## **ADDENDUM-1**

**Dust Suppression and Water Systems Package for Singrauli STPP Stage-III (2x800 MW)**

**Tender Ref: 77/24/6170/BPA**

**Pre-Bid Clarification-01 dtd 14.03.2025**

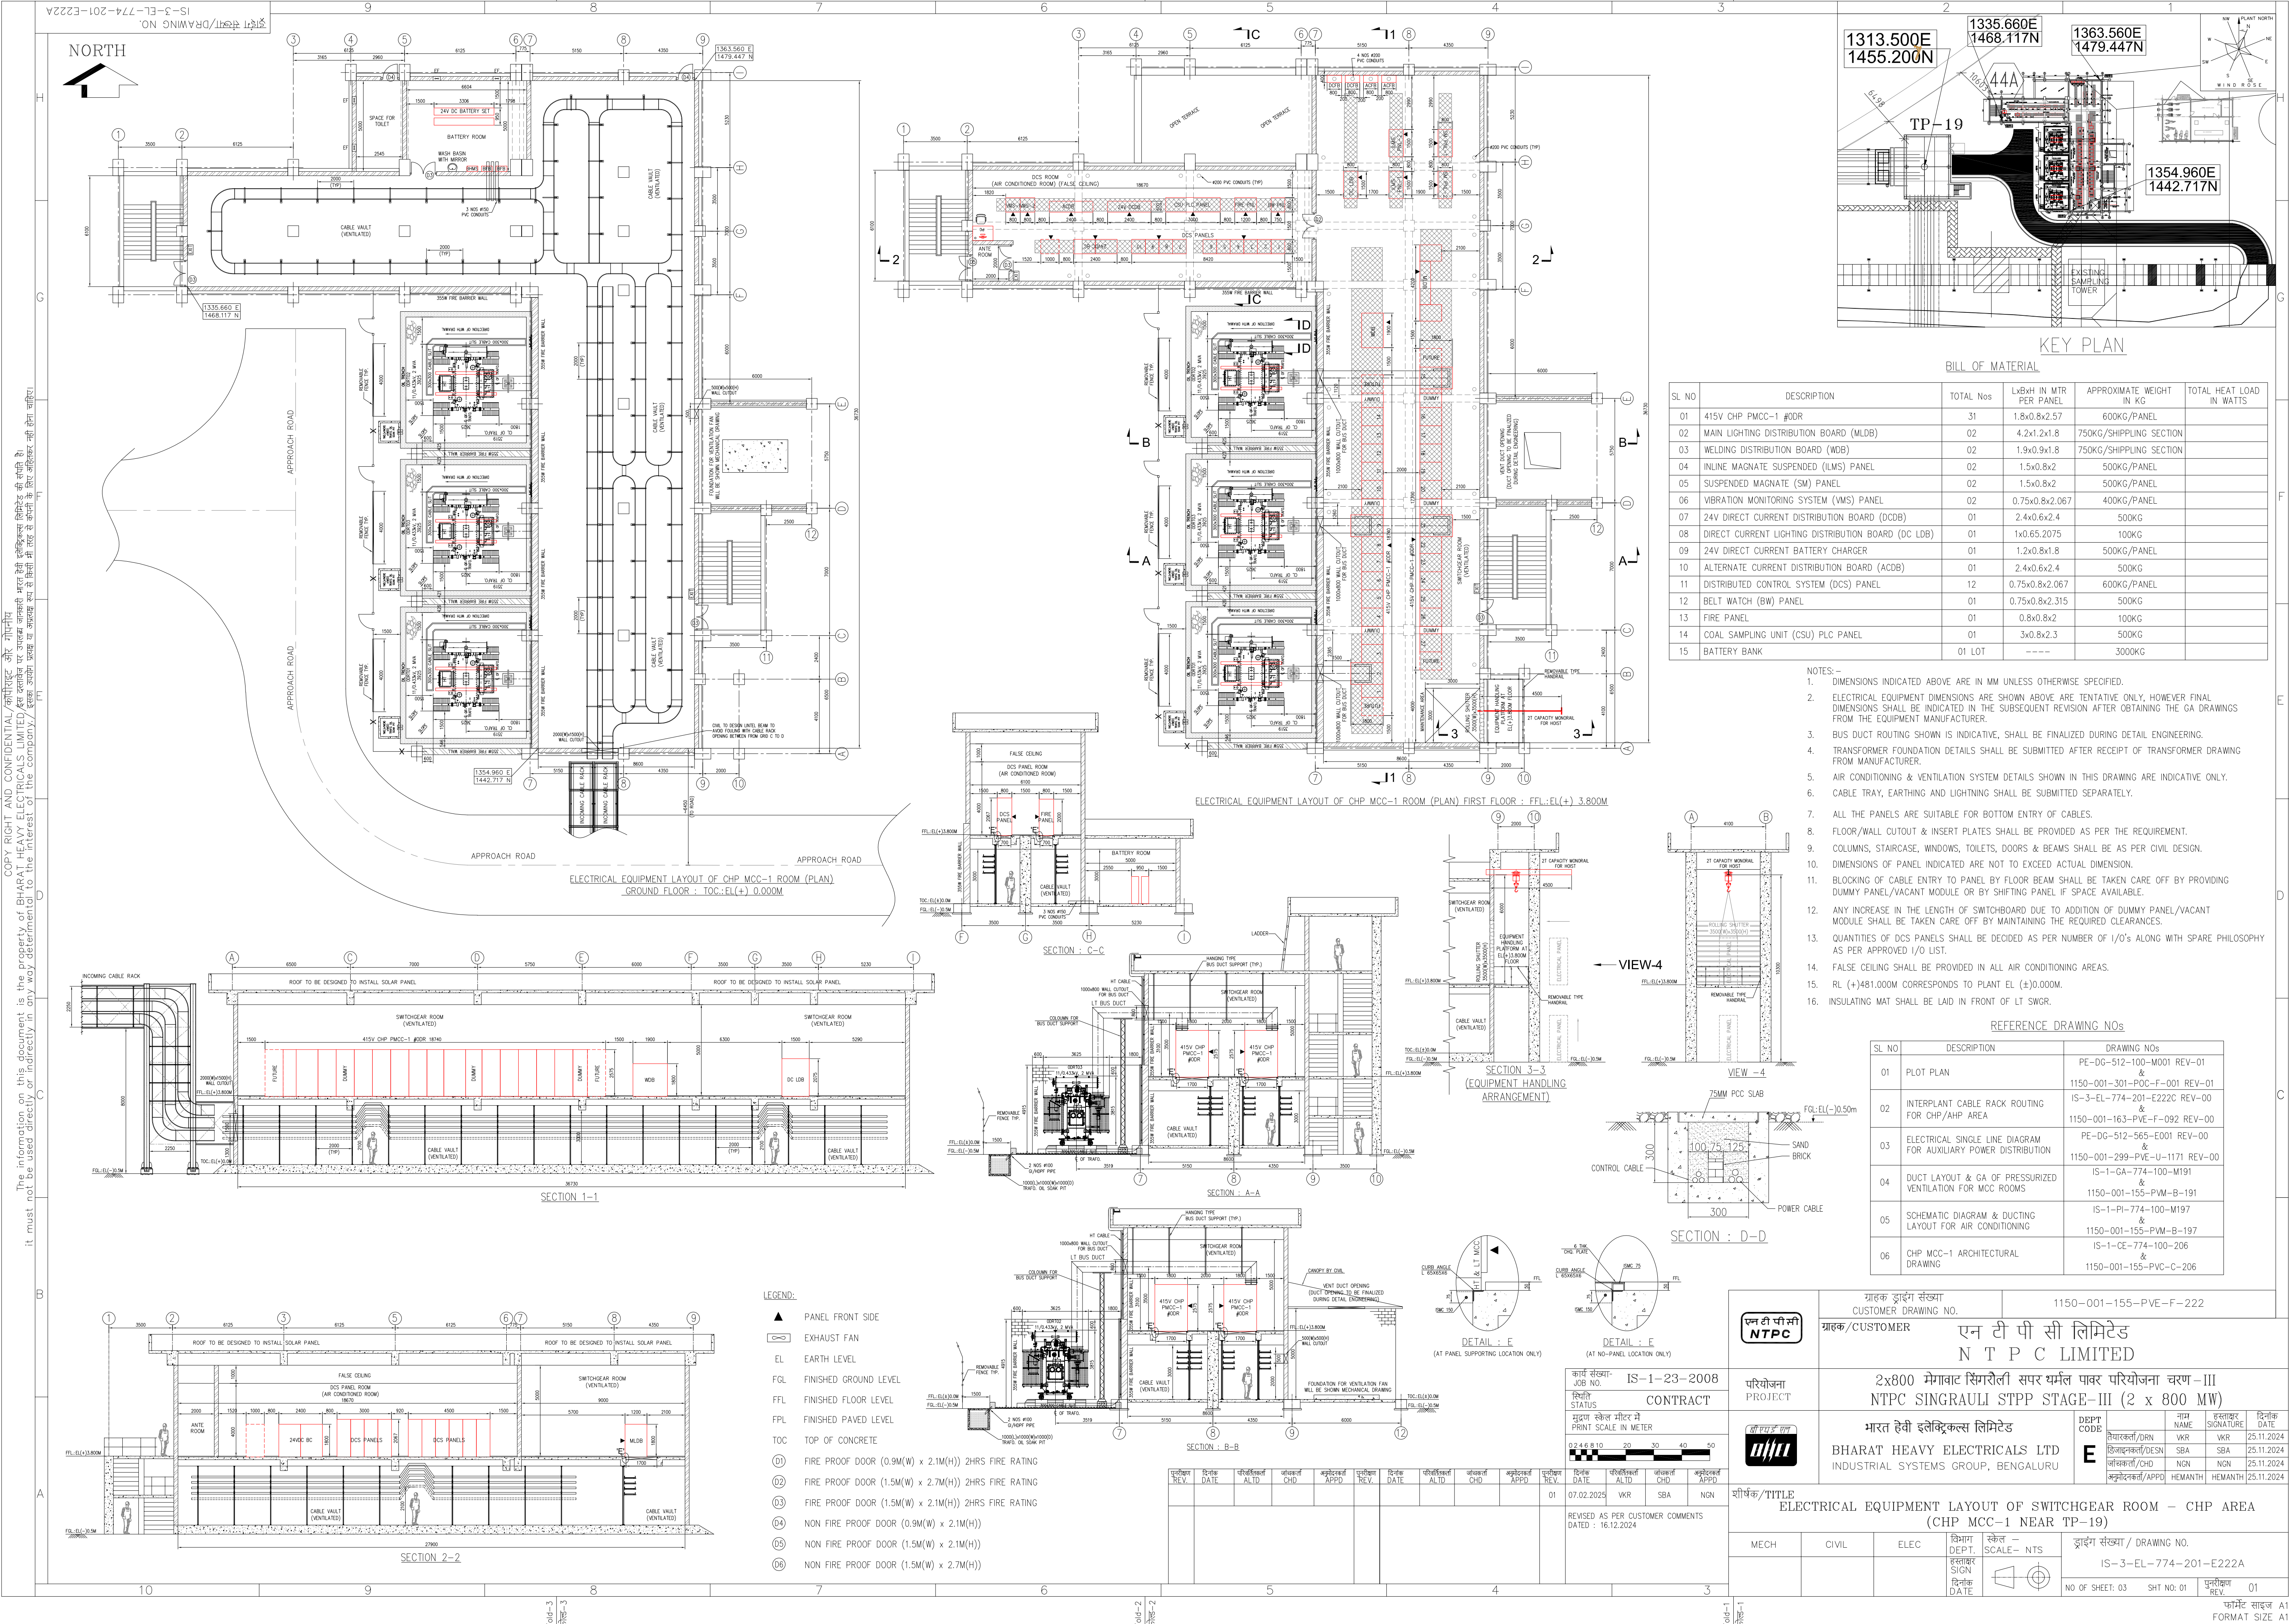
Sl. No.	Tender Document Description	Clause No.	Page No.	Existing Provision	Bidder's Query	Clarification by BHEL
20	-	-	-	General Query	1. GA of building for SW and PW System other than TPs. (for LHP System, MCC buildings, Toilets, Etc.)	 <p>5. Control room located near TP-24 marked in plot plan. Further snap taken from plot plan highlighting the control room is attached below for your ready reference</p>  <p>1. Bidder to refer SI No. 6 i) to xii) of Annexure-5 of technical enclosures for drawings of Buildings and conveyors.</p>
